Subject: Oak Bluffs Bowling Alley – Sound Control

At your request, I have reviewed the site plan and drawings for the proposed bowling alley in Oak Bluffs. The proposed new building would be just a few feet from the west property line, and the adjacent properties to the west are existing houses. This letter presents my analysis and recommendations to minimize bowling and other sounds transmitted through the walls of the building.

Site Plan showing areas for special exterior wall detail

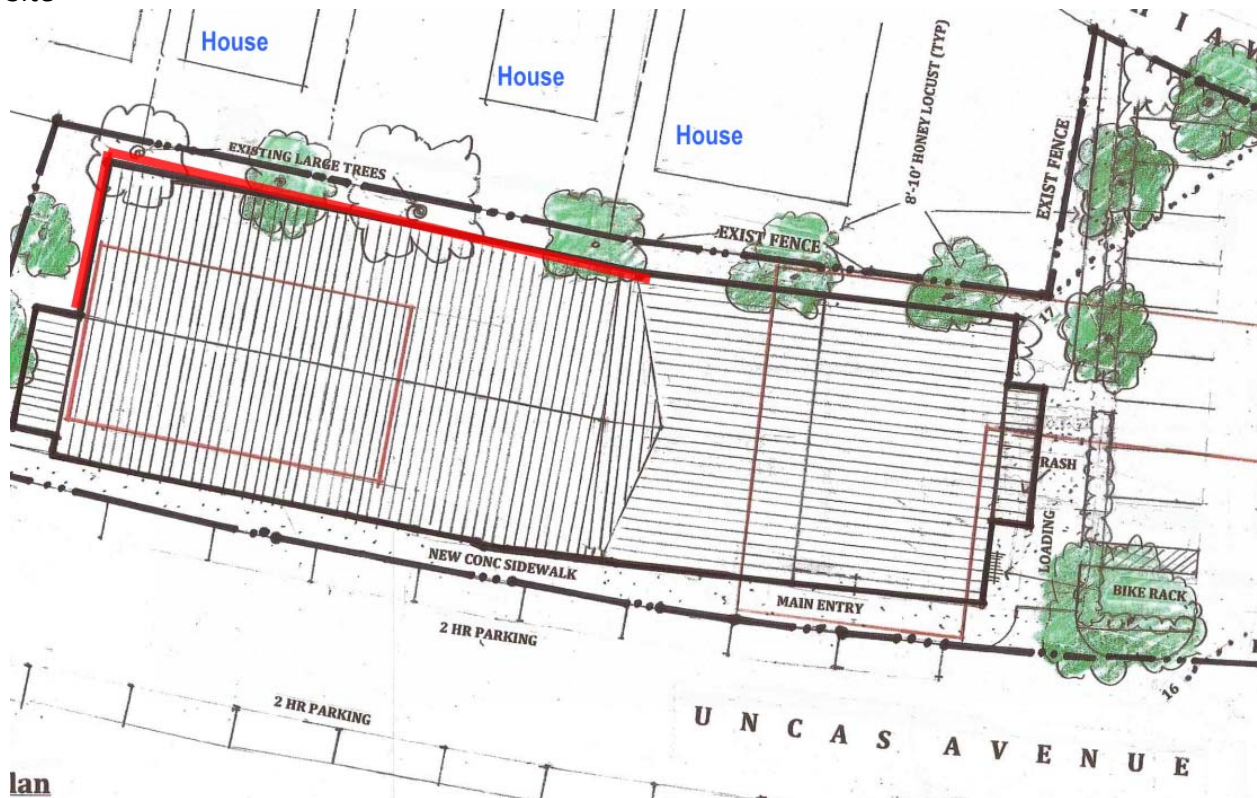
I recommend upgrading the standard construction to improve sound isolation. This includes upgrading the south and east walls, and part of the south side of the bowling alley roof. The figure below is a markup of your site plan. The red line denotes areas of the exterior walls that should be upgraded for sound isolation.
